DATE: January 19, 2007

Addenda No. 01

SUBJECT: HCRH Interpretive Sites & Signs
Historic Columbia River Highway
Multnomah, Hood River, and Wasco Counties
Grading, Drainage, Paving, Signing, and Roadside Development Project
(Bids to be opened and read February 1, 2007)

02001.50 Concrete Mix Tolerances and Limits General - Modify Table 02001-3 as follows:

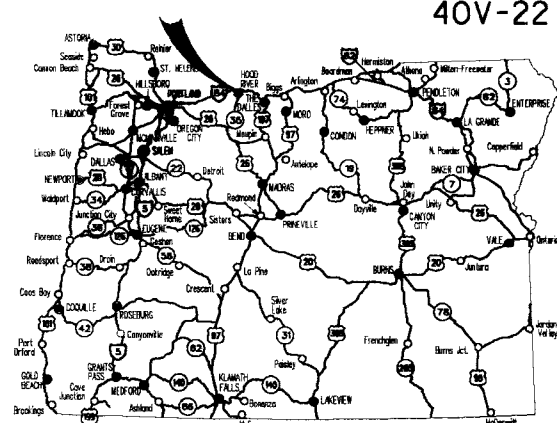
Under the Limits column, replace "75 mm - 200 mm (3" - 4")" with "75 mm - 200 mm (3" - 8)".

In the last row of the table, replace "Maximum Water-Cement Ration express as $w/(c+p)$ " with "Maximum water-cementitious ratio express as w/cm ", and replace "Water-cement ratio may not exceed the values in Table 02001-1" with "Water-cementitious ratio may not exceed the values in Table 02001-1".

PLANS FOR PROPOSED PROJECT

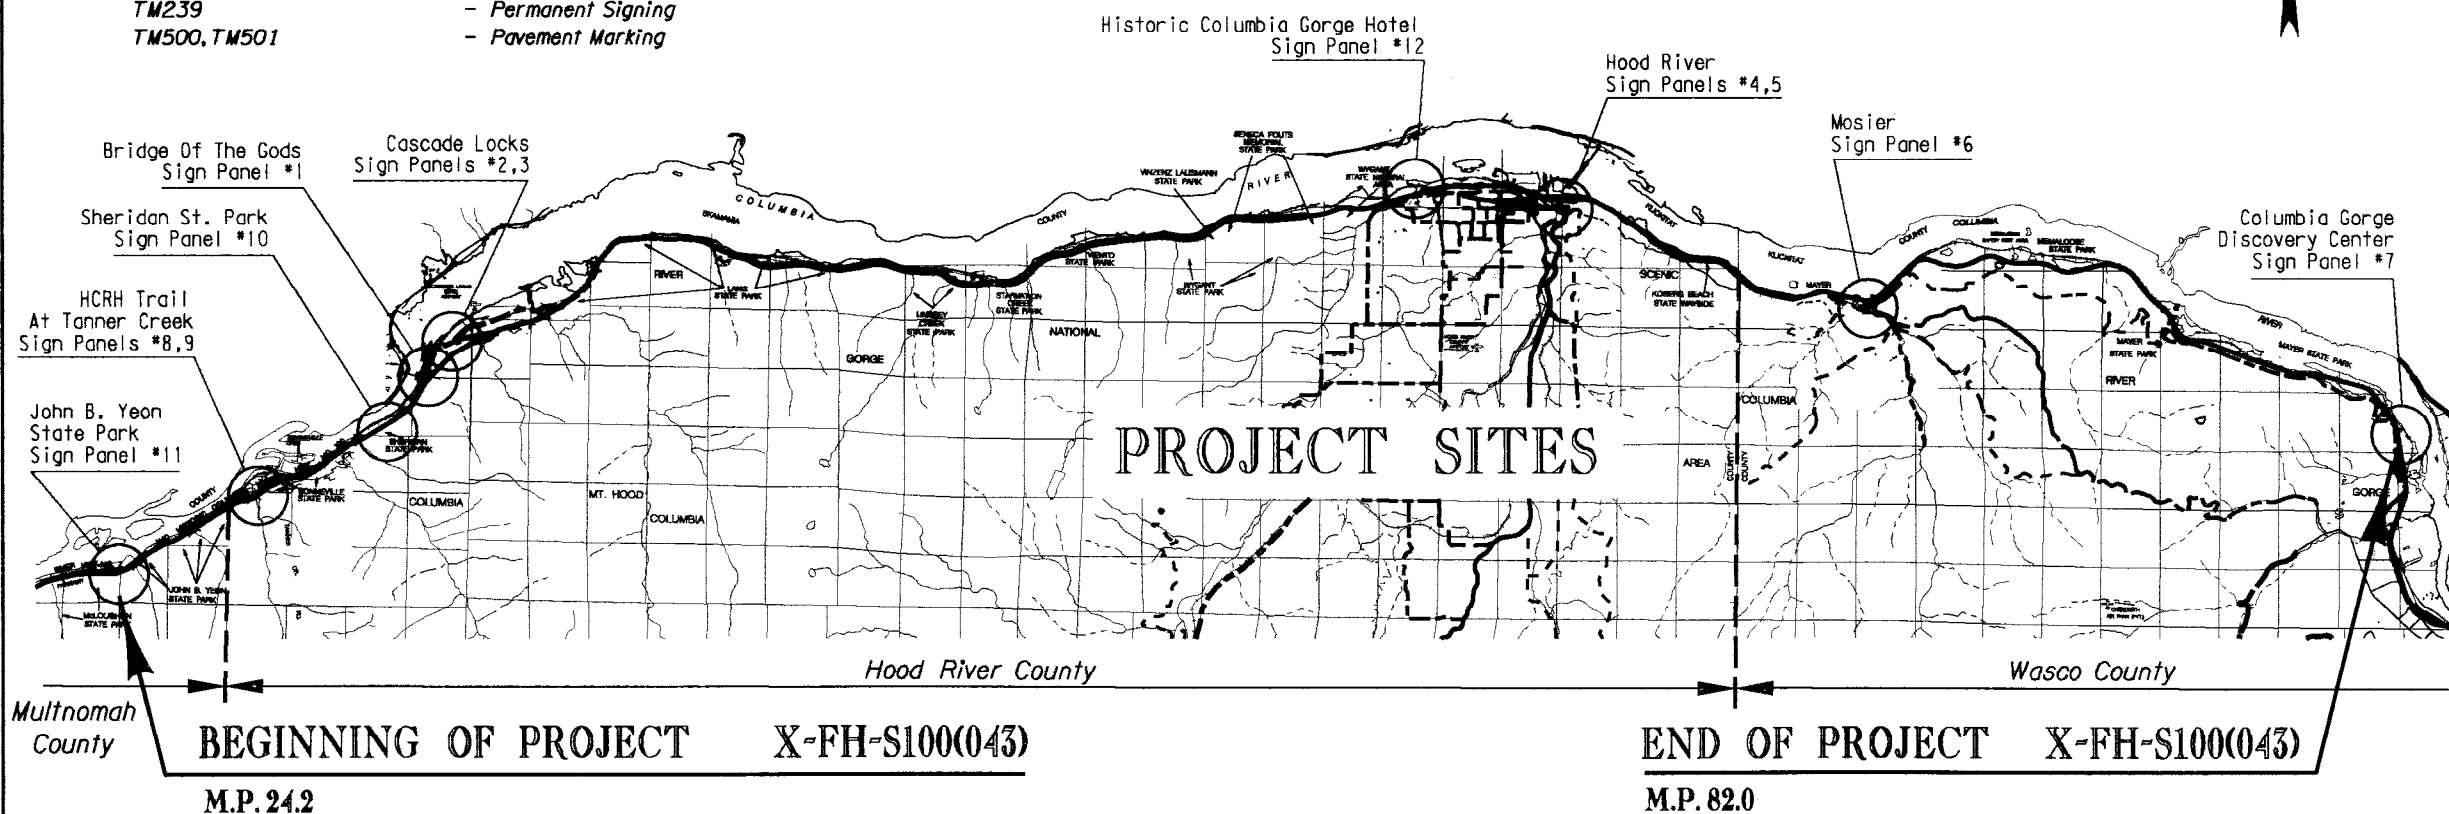
01/19/07 - Added Std. Drg. No.

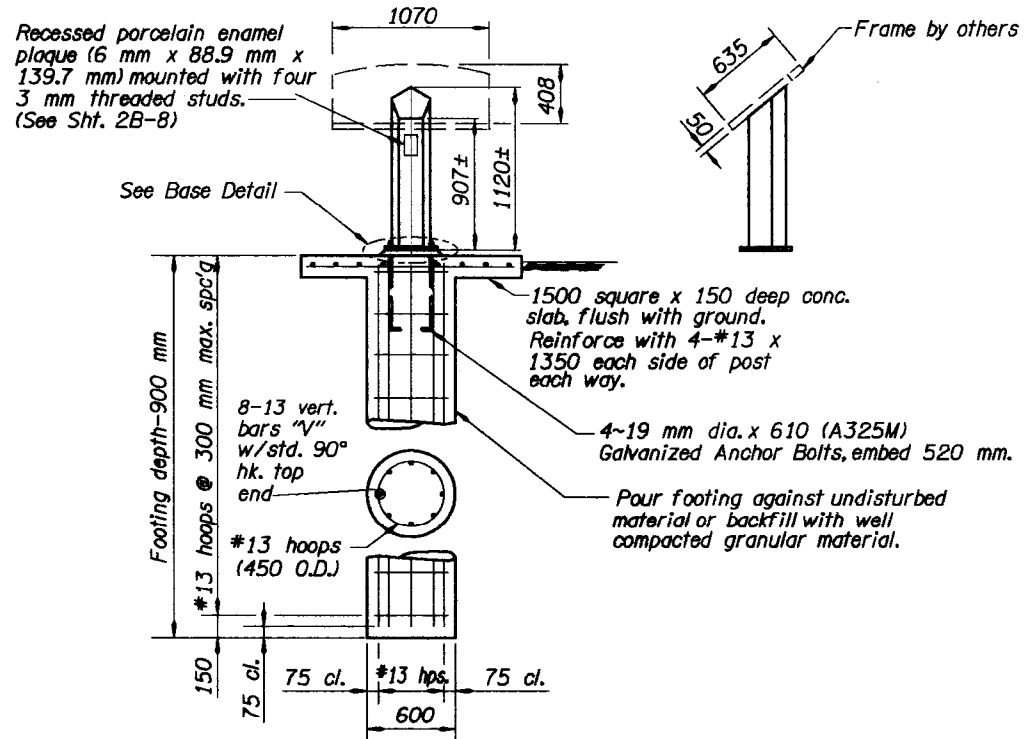
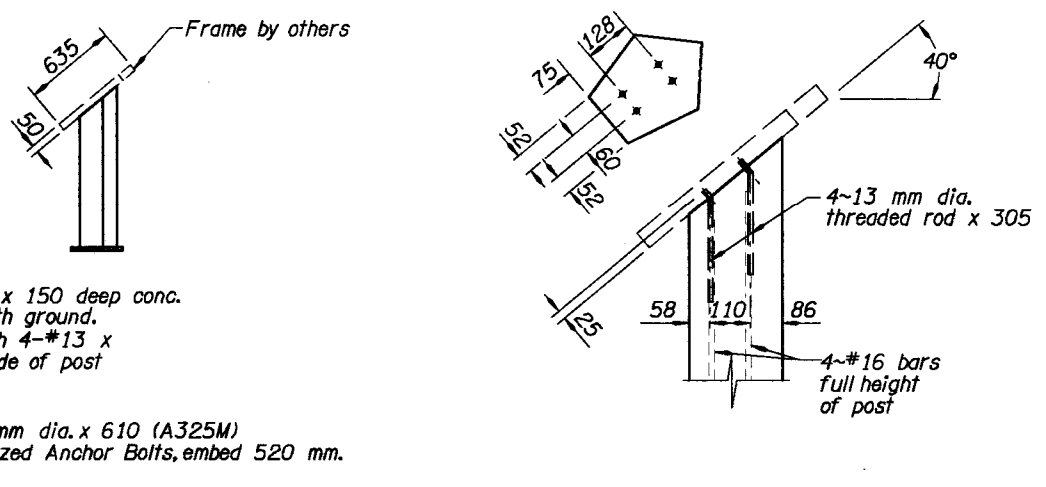
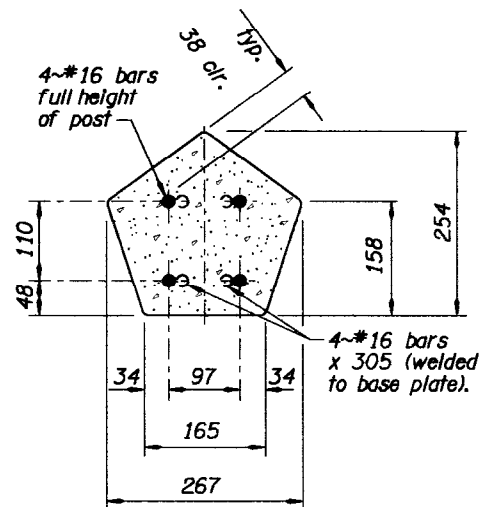
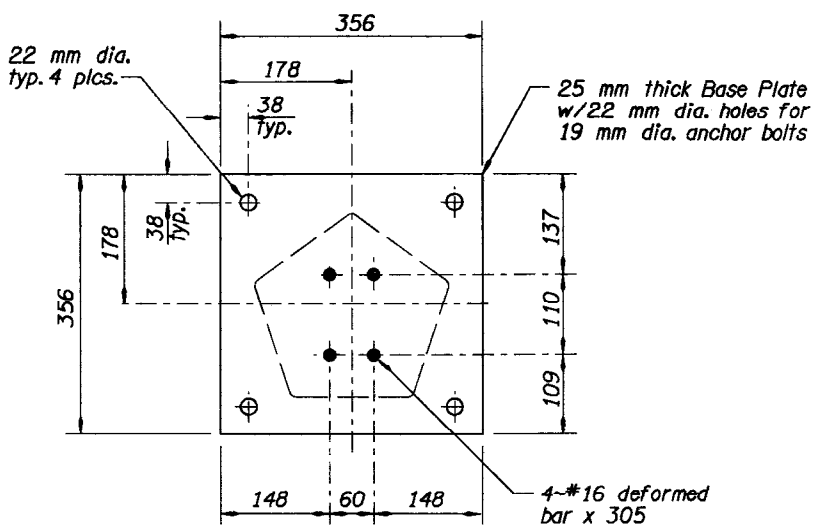
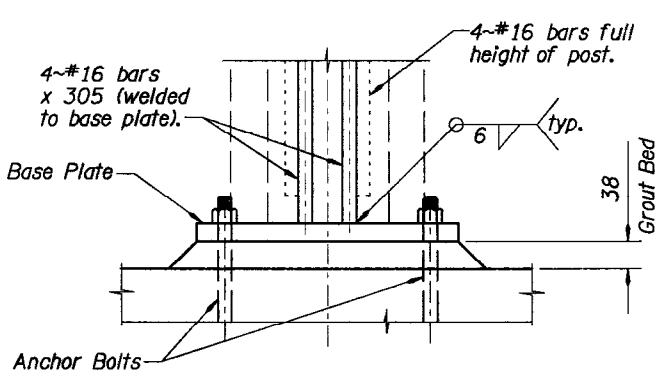
01/19/07 - Changed General Note Text
